# Planning Report

Response to LRD Opinion

Proposed Large Scale Residential Development (LRD) at Railpark  
West, Maynooth, Co. Kildare

PREPARED BY MCG PLANNING

Figure 14: Proposed Creche Facility

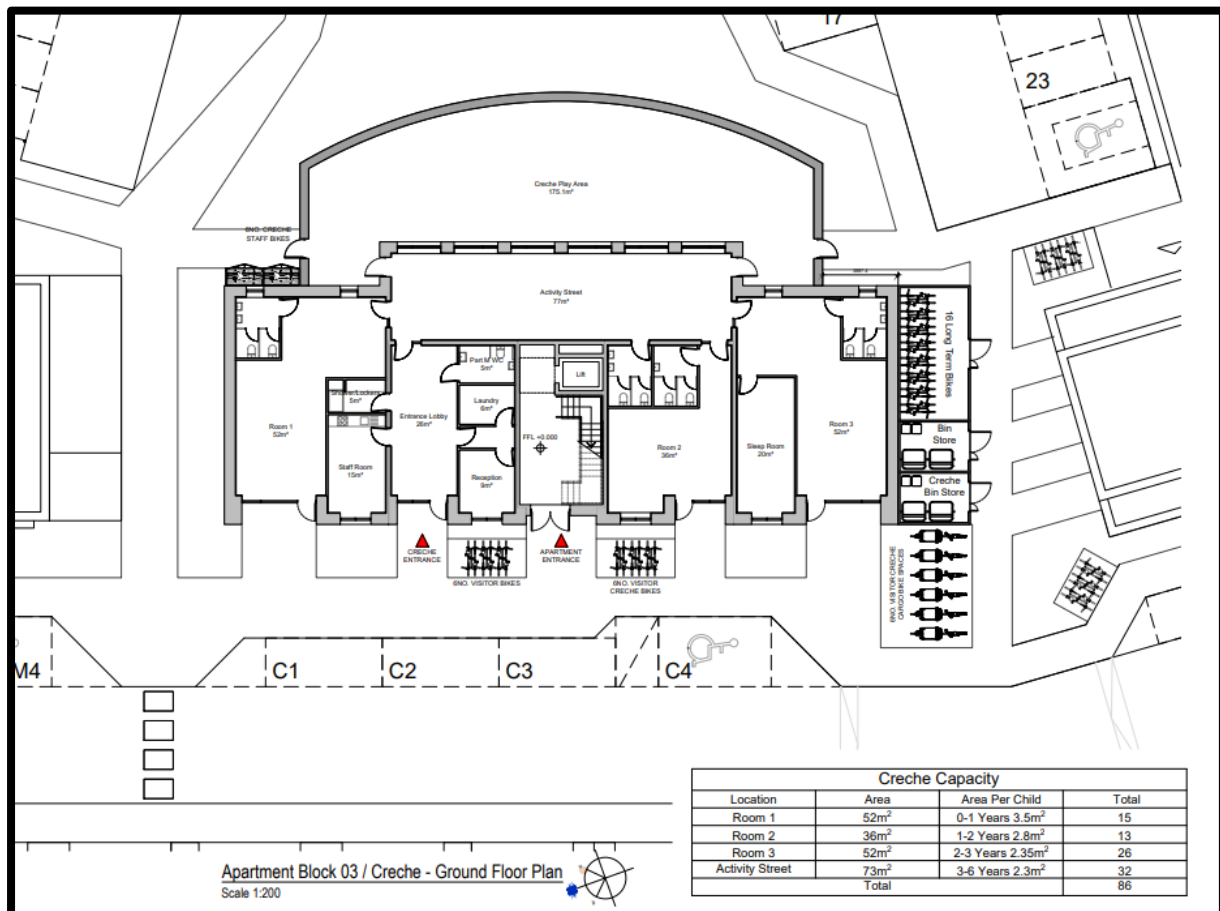
- 1. The proposed layout does not reflect the urban design requirements under UD 01 of the Kildare County Development Plan 2023-2029 and the design checklist outlined within Appendix D of the Sustainable and Compact Settlements Guidelines for Planning Authorities particularly in relation to the overdominance of car parking around the apartments blocks, the open space to the northeast of the site that is not sufficiently overlooked, inappropriate layout in the northwest of the site particularly in relation to the area around unit 13, poor communal open space design due to bin and bike store on communal open space 1 and the location of communal open space 2, and the lack of set down for the crèche and the access to the crèche very close to the entrance to the development.*

The creche is now centrally located within the development at ground floor level of Block 03, providing easy access for residents and encouraging multimodal transport. A set-down area for four cars is situated directly in front of the creche, with additional staff parking for four vehicles located to the south adjacent to the main public open space. The facility includes an enclosed, secure play area at the rear, adjoining the communal courtyard, accommodating all age groups along with staff and support areas. On this basis the sizing of the creche is considered appropriate for the development. This will have a positive effect on population and human health as the proposed creche will accommodate and exceed for 88 no. childcare spaces required which is more than the need generated by the development.
